APPLICATION NO.	FILING DATE	FIRST NAMED INVENTOR	ATTORNEY DOCKET NO.	CONFIRMATION NO	
09/849,342	05/07/2001	David M. Britz	3493.00073	1125	
	7590 07/03/2003				
BANNER & WITCOFF LTD., ATTORNEYS FOR AT & T CORP		EXAMINER			
1001 G STREET, N.W. ELEVENTH STREET			ULLAH,	LAH, AKM E	
	ON, DC 20001-4597		ART UNIT	PAPER NUMBER	
			2874		
			DATE MAILED: 07/02/2002

Detailed Action

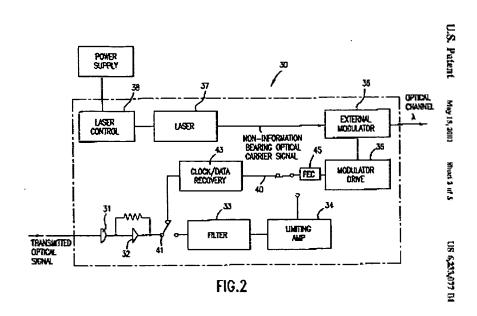
Claims 1-15 are rejected under 35 U.S.C. 103(a) as being unpatentable over Alexander et al (USPNO. 6,233,077) in view of Herman et al (USPNO. 6,144,679)

Alexander et al disclose all the claimed subject structures except for a telescope as claimed. Alexander further teaches the use an FEC encoder (as claimed in claim 6) in column 6 of Alexander et al.

The use of telescope and/or lenses which are substitutes for telescope is very elementary teachings in this optical art as is shown in Herman et al. Numerals 42 & 44 are telescope mentioned in figure 1 of the reference.

It would have been obvious to one having ordinary skill in the art at the time the invention was made to utilize such telescope/lenses of the device of Herman et al in Alexander et al which would provide a free space wavelength duplexed optical communication link that is reduces the effects of fading since, with both device being directed to a common use in the same environment, there is an implies suggestion for applying the teachings of one to the other. That is, the skilled worker who is presumed to have knowledge of the prior art, with these two references (Alexander et al in view of Herman et al) before him, would immediately recognize the desirability of employing the telescope teachings of Herman et al to the device of Alexander et al, as claimed.
